DATE: 10.21.2013
TO: ProTrak
FROM: Bill McDow
 Transportation Planning

■ **THE CREEK AT WILLOWICK [plan review #3]**

Figure 3B-13. Examples of Markings for Obstructions in the Roadway (Sheet 1 of 2)

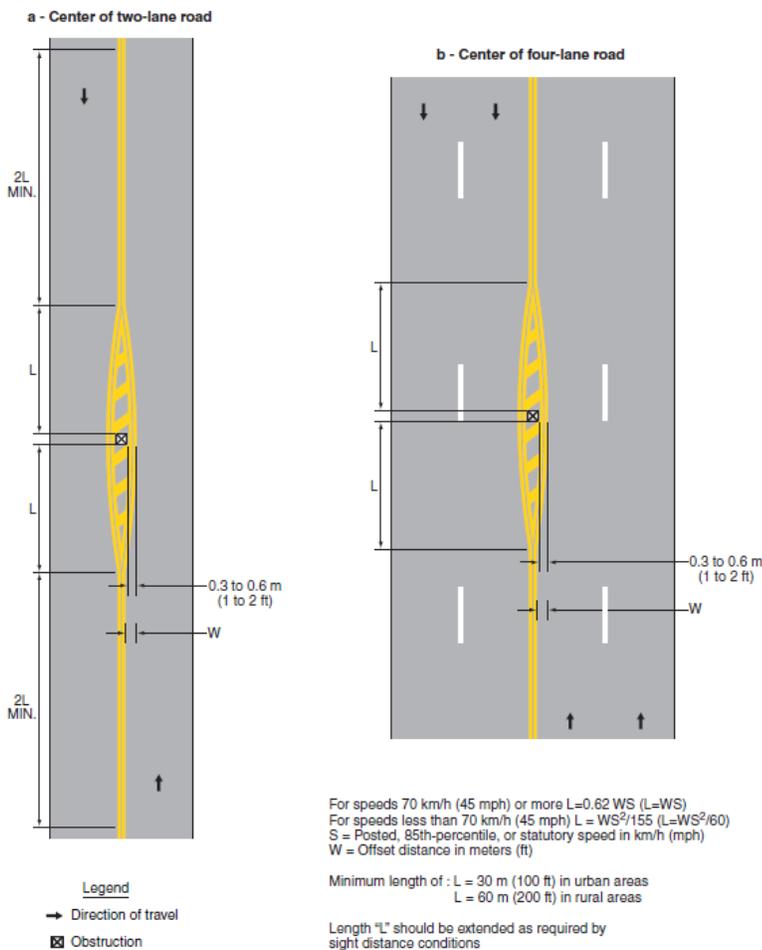
3. Show lane width for the landscaped traffic islands on the site plans.
4. Revise the landscaped traffic island detail to show the pavement marking delineation for the islands per the MUTCD. The total length of the lane line and taper section of the approach markings shall be a minimum of 2L as calculated for the obstruction. A reference to the applicable section is included below:

Section 3B.10 Approach Markings for Obstructions

Standard:

Pavement markings shall be used to guide traffic away from fixed obstructions within a paved roadway. Approach markings for bridge supports, refuge islands, median islands, and raised channelization islands shall consist of a tapered line or lines extending from the centerline or the lane line to a point 0.3 to 0.6 m (1 to 2 ft) to the right side, or to both sides, of the approach end of the obstruction (see Figure 3B-13).

For roadways having a posted or statutory speed limit of 70 km/h (45 mph) or greater, the taper length of the tapered line markings should be computed by the formula $L = 0.62 WS$ for speeds in km/h ($L = WS$ for speeds in mph). For roadways where the posted or statutory speed limit is less than 70 km/h (45 mph), the formula $L = WS^2/155$ for speeds in km/h ($L = WS^2/60$ for speeds in mph) should be used to compute taper length.
